PITTSFIELD TOWNSHIP PLANNING COMMISSION AGENDA

Monarch Estates

Project:
CSPA 19-17

PITTSFIELD TOWNSHIP, WASHTENAW COUNTY, MICHIGAN
 SINGLE-FAMILY RESIDENTIAL SITE CONDOMINIUM
 PHASE I FINAL SITE PLANS

SECTION 22	TOWN 3 SOUTH, RANGE 6 EAST	PITTSFIELD TOWNSHIP	WASHTENAW COUNTY, MICHIGAN
SE MICHIGAN LAND HOLDINGS LLC	MONARCH ESTATES	PHASE I FINAL SITE PLAN	EXISTING CONDITIONS & DEMOLITION PLAN

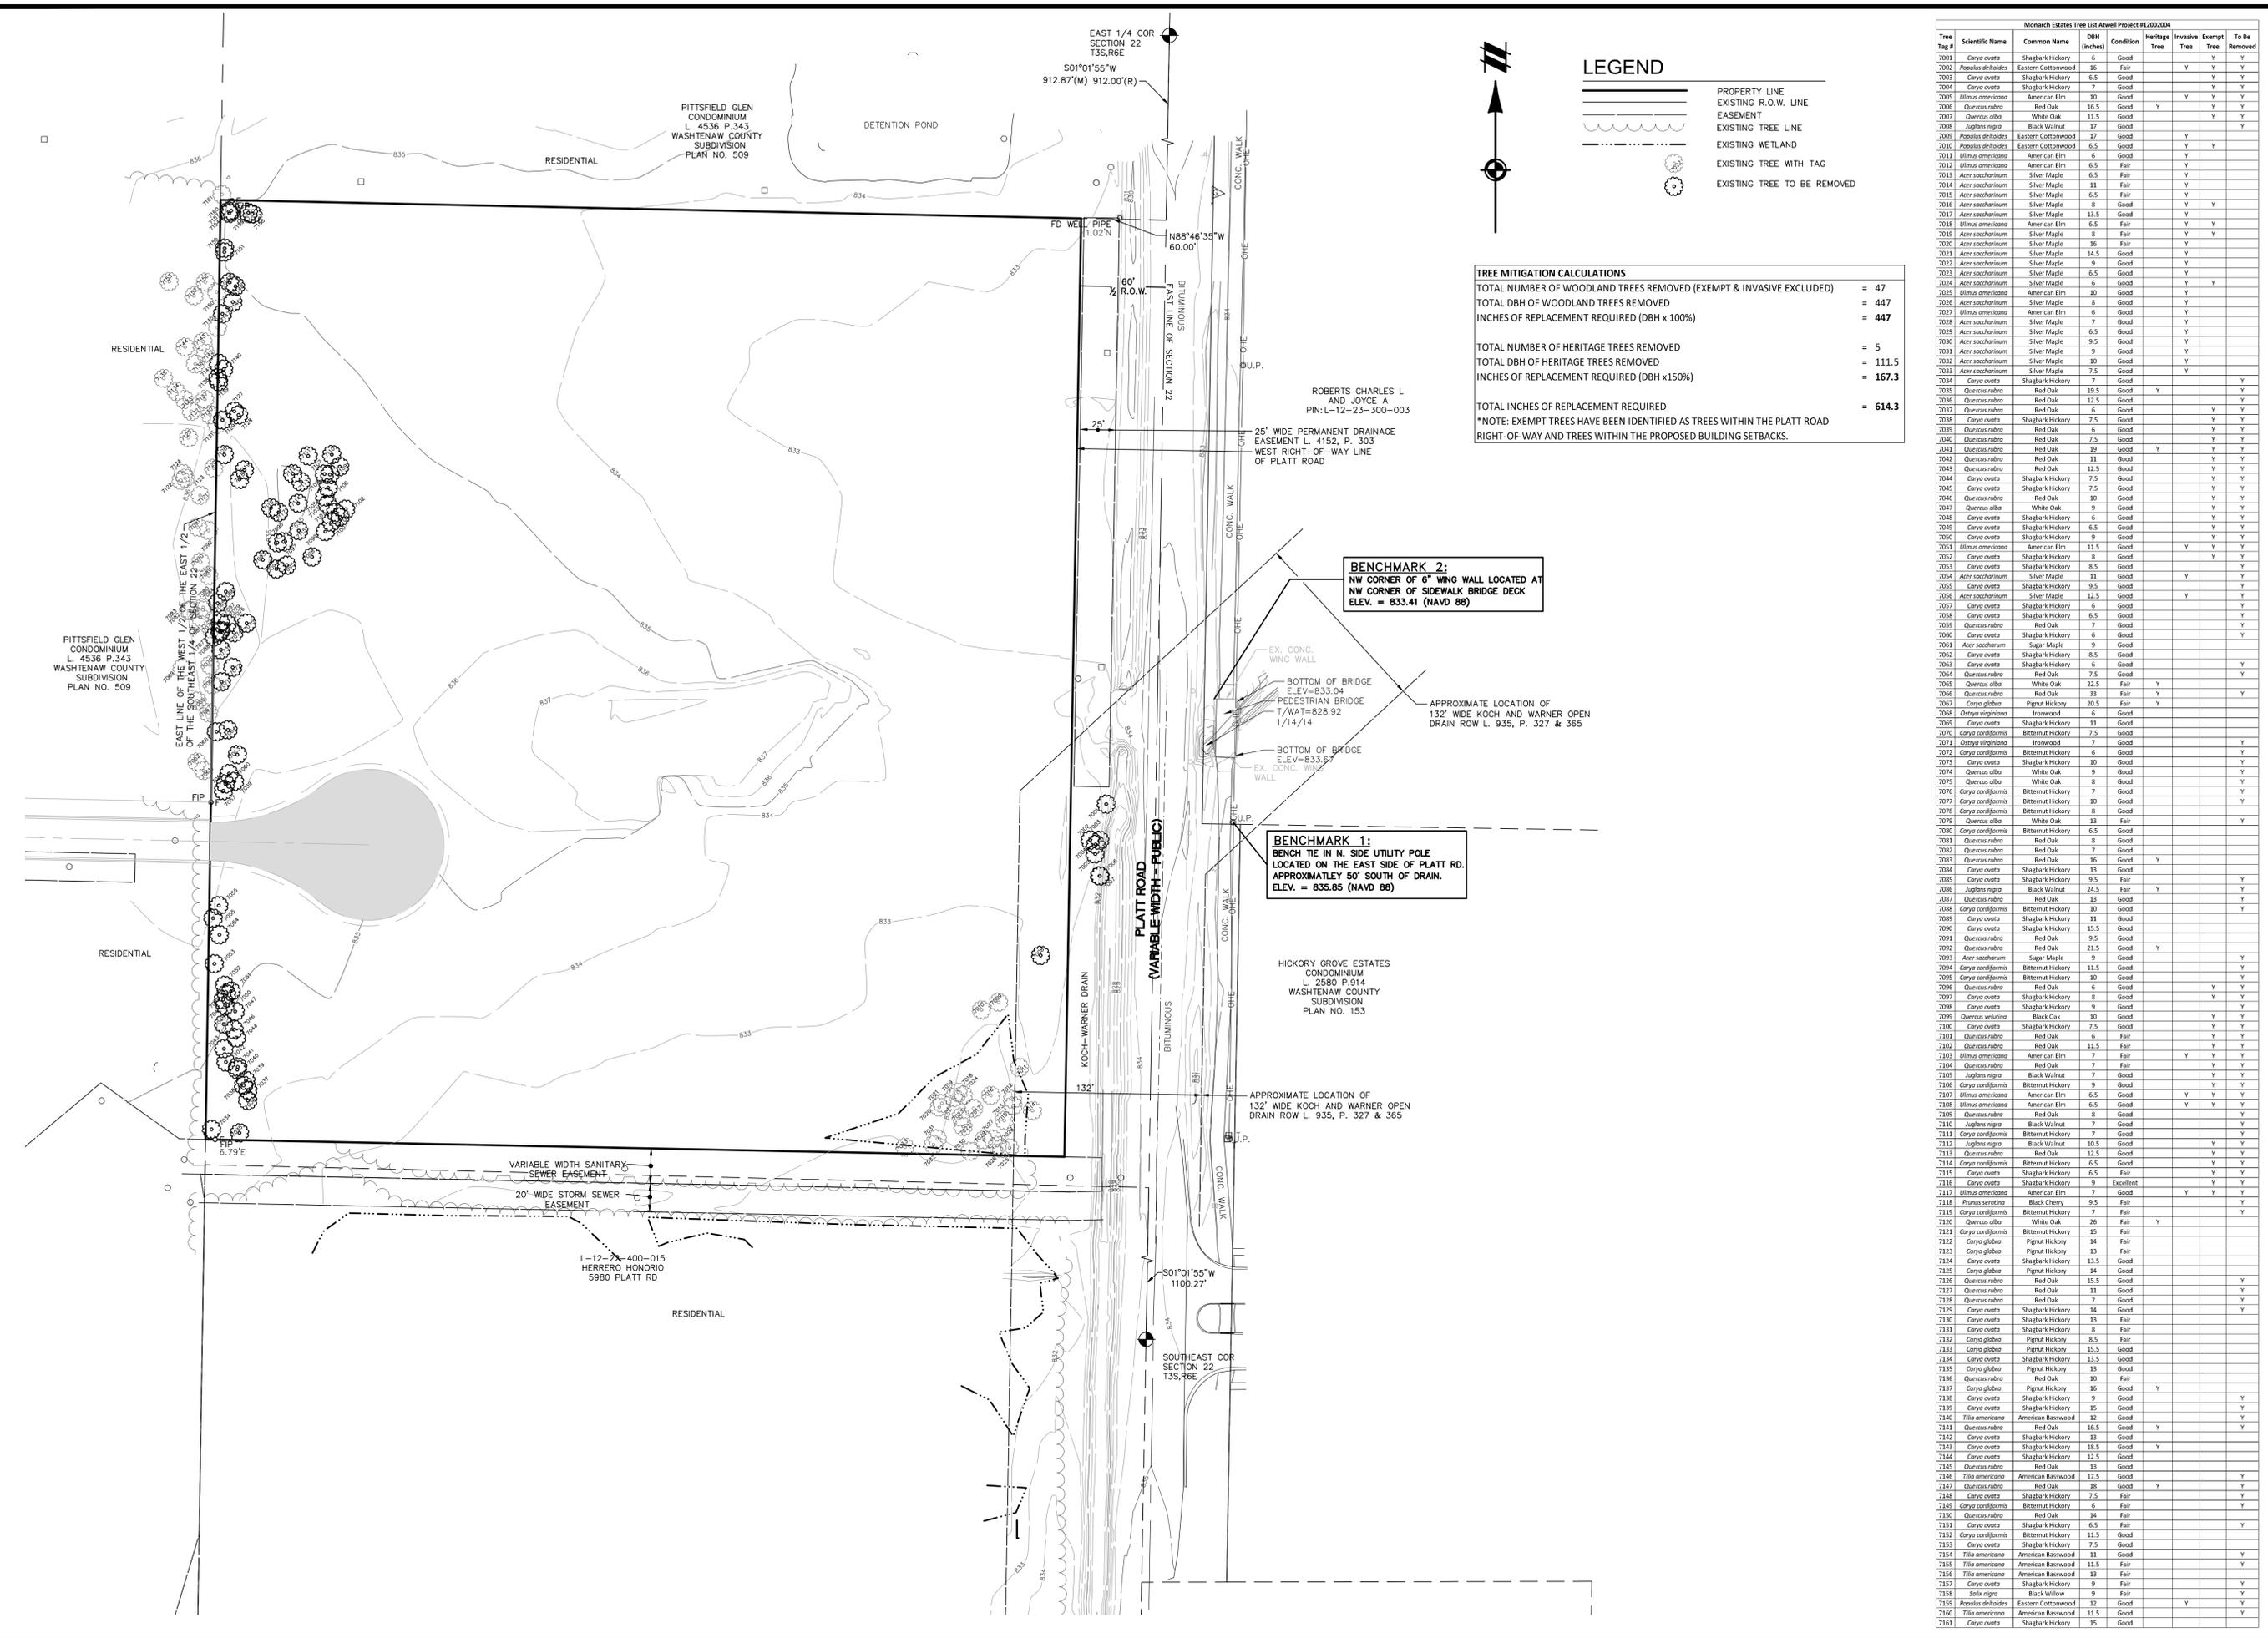
1. Sheet 2; Existing conditions & Demolition Plan
 - a. An existing gas main was encountered along the east side of Platt Road during the water main tie-in for the neighboring Pittsfield Glen. The Applicant shall verify the location of the gas main. If the gas main is present, it shall be potholed at the water main tie-in location prior to construction to verify there is adequate space for a gate well. A note shall be added to the plan accordingly.
2. Sheet 3; Existing Natural Features Plan
 - a. A tree survey shall be included.
 - b. A wetlands mitigation plan shall be provided.
3. Sheet 4; Soil Erosion & Sedimentation Control Plan
 - a. Erosion control blanket should be shown on or noted at all slopes steeper than 1:4.
 - b. The mud tracking mat should be shown across the entire site entrance. At a minimum it shall be 20 feet by 100 feet.

AN EXISTING GAS MAIN WAS ENCOUNTERED ALONG THE EAST SIDE OF PLATT ROAD DURING THE WATER MAIN TIE-IN FOR THE NEIGHBORING PITTSFIELD GLEN. THE APPLICANT SHALL VERIFY THE LOCATION OF THE GAS MAIN. THE GAS MAIN SHALL BE POTHOLED AT THE WATER MAIN TIE-IN LOCATION PRIOR TO CONSTRUCTION TO VERIFY THERE IS ADEQUATE SPACE FOR A GATE WELL.

SE MICHIGAN LAND HOLDINGS LLC
MONARCH ESTATES
PHASE I FINAL SITE PLAN
LAYOUT PLAN

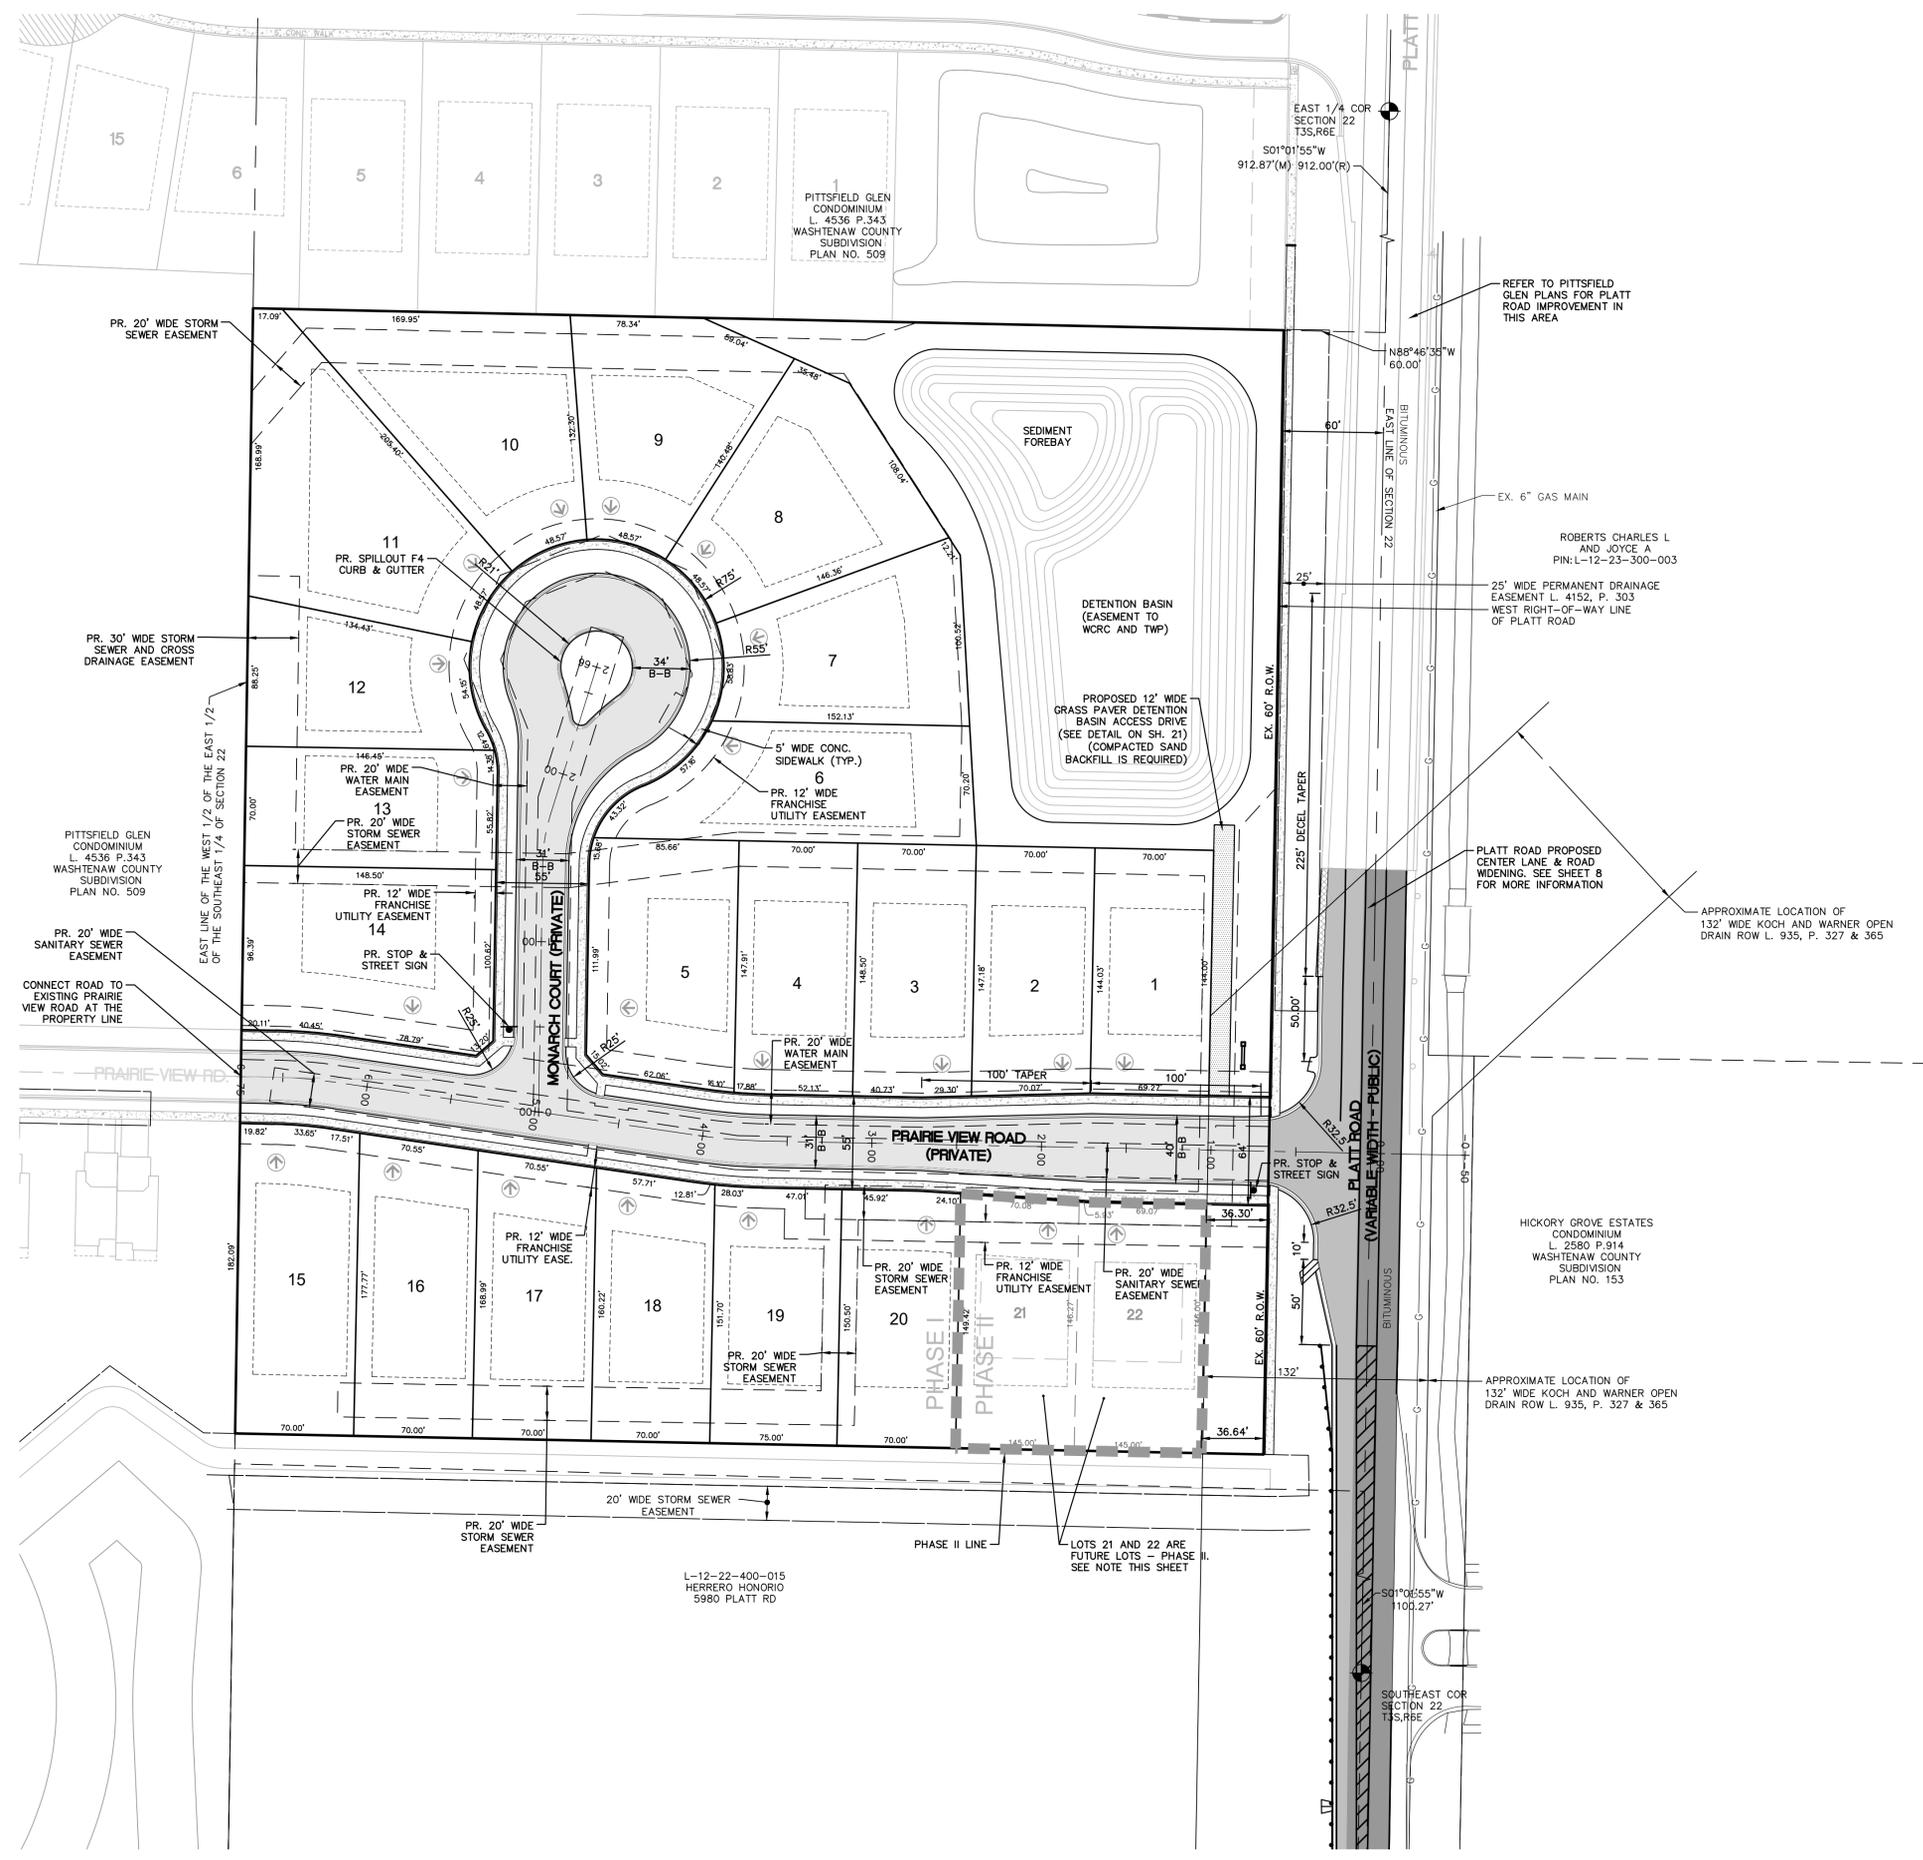
CWA COMMENT: Information related to the location of floodplain on Lots 18 through 22 and compliance with Section 14.07 has not been provided. The location of the floodplain should be demonstrated on Sheet 5 in relation to the lot configuration.

SE MICHIGAN LAND HOLDINGS LLC
MONARCH ESTATES
PHASE I FINAL SITE PLAN
GRADING PLAN

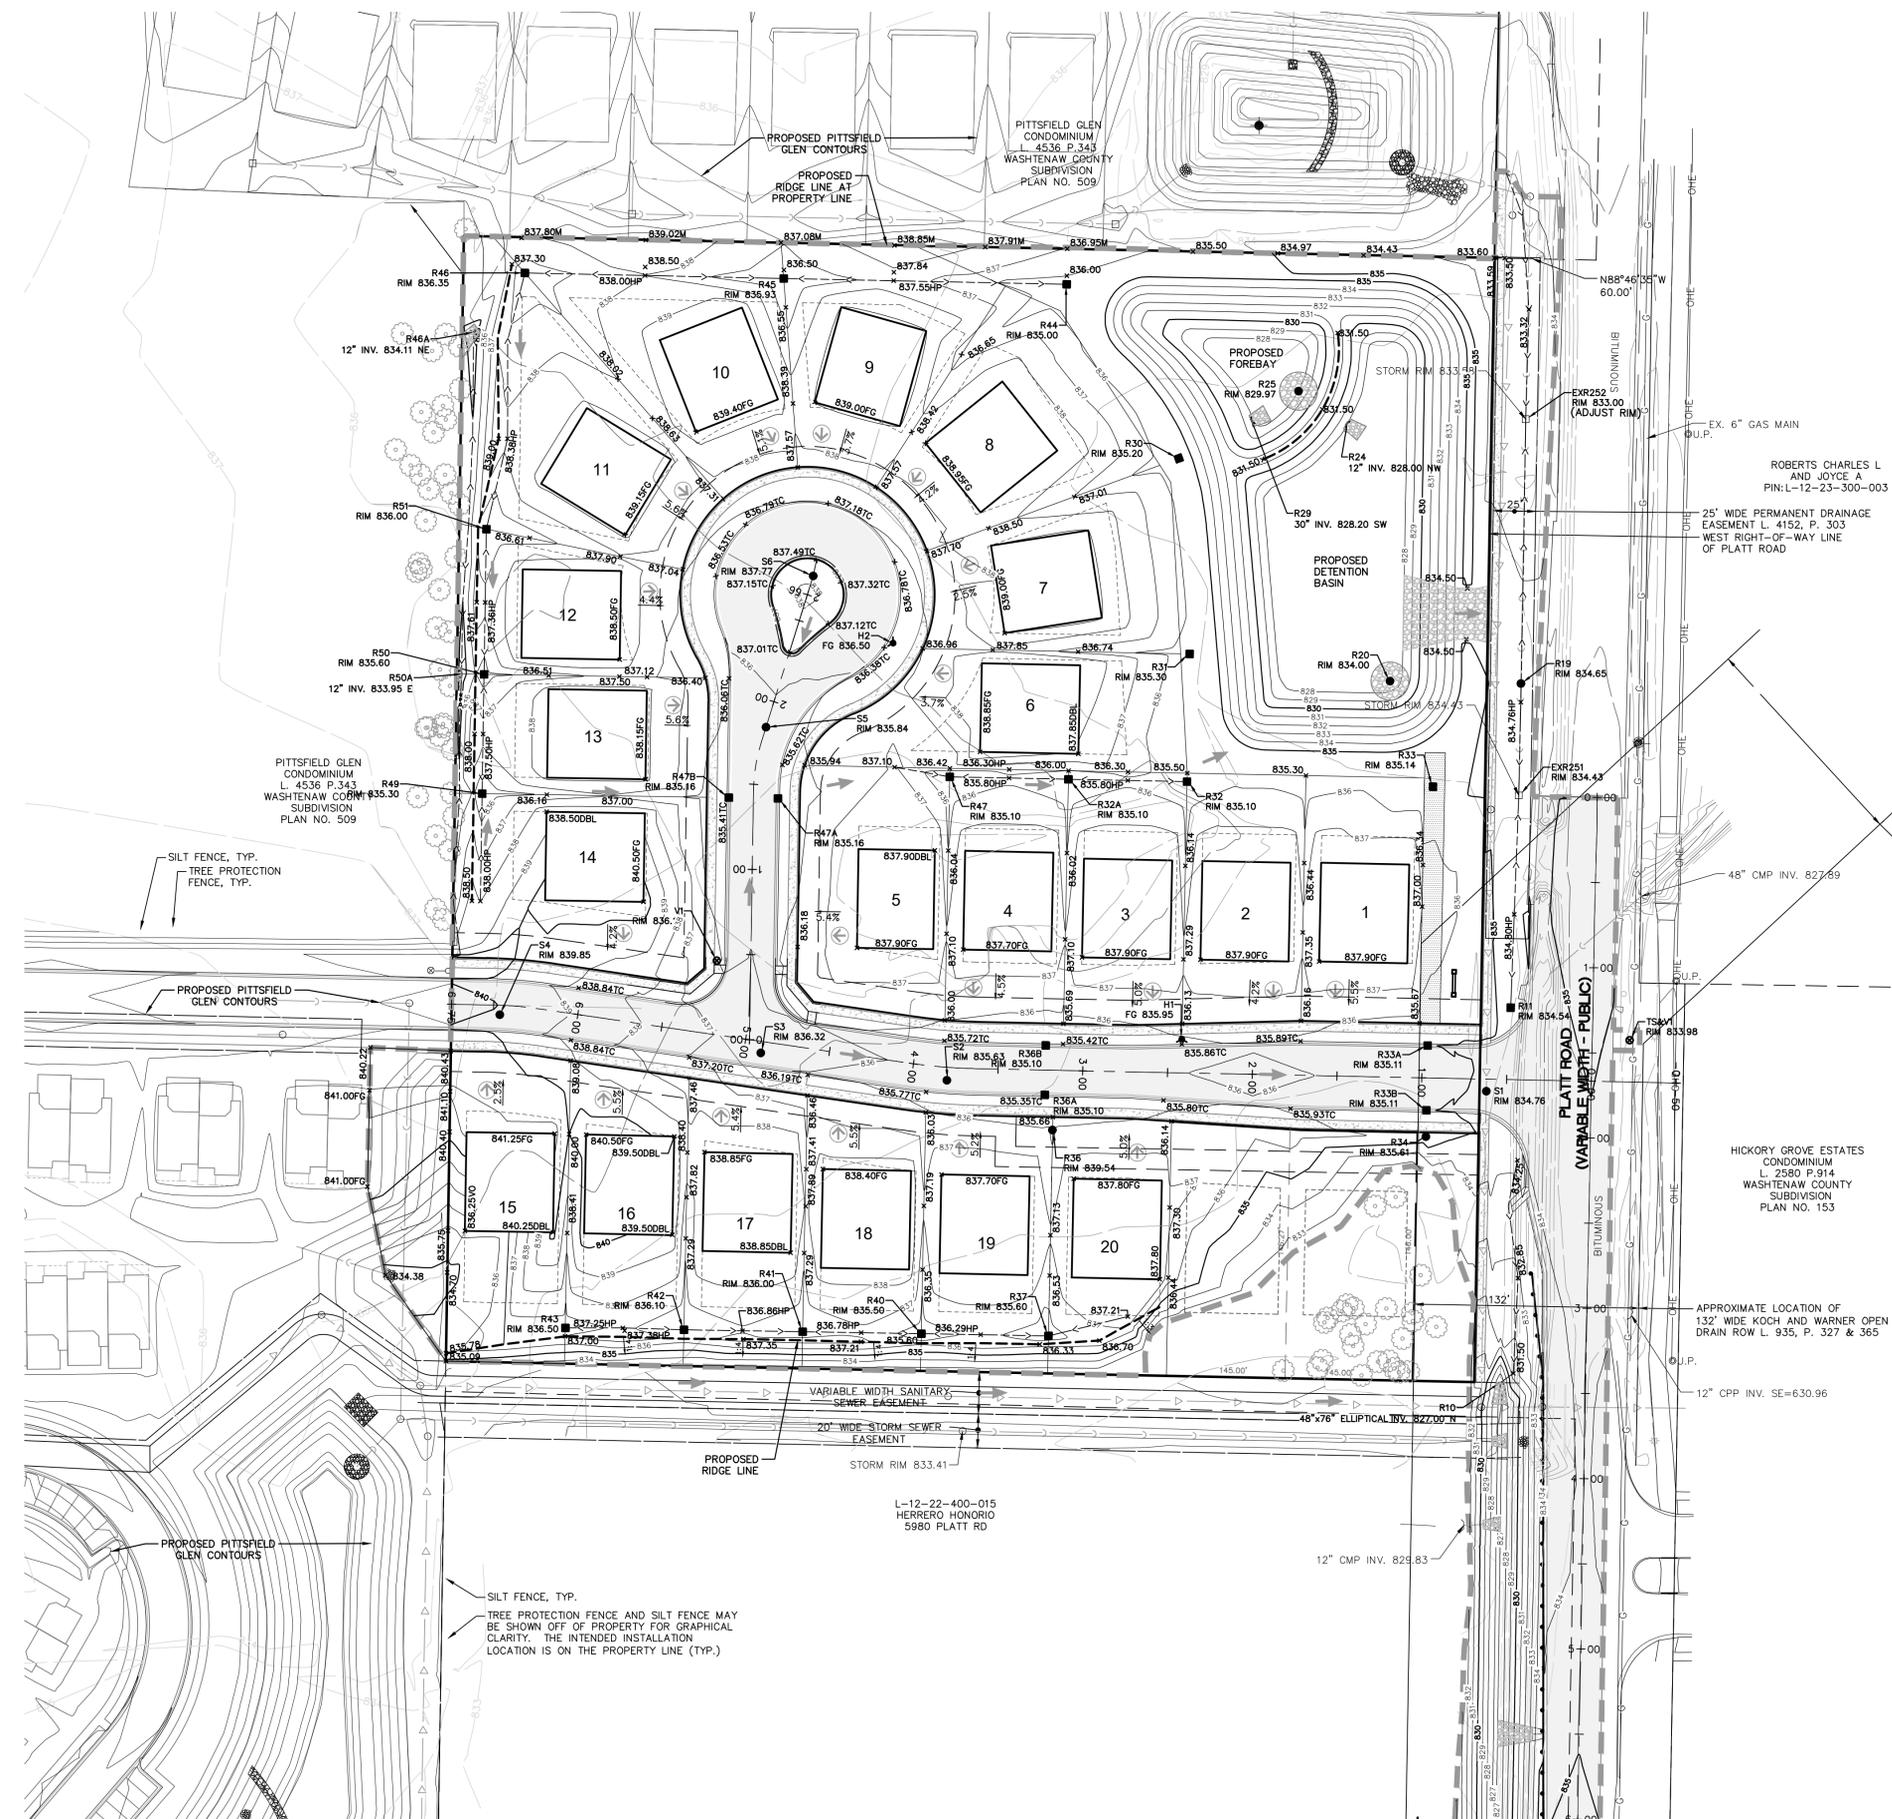
4. Sheet 6; Layout Plan
 - a. "Monarch Court (Private)" in the plan view shall be moved for readability.
 5. Sheet 7; Grading Plan
 - a. The top of curb elevations for the median in the cul-de-sac shall be noted.
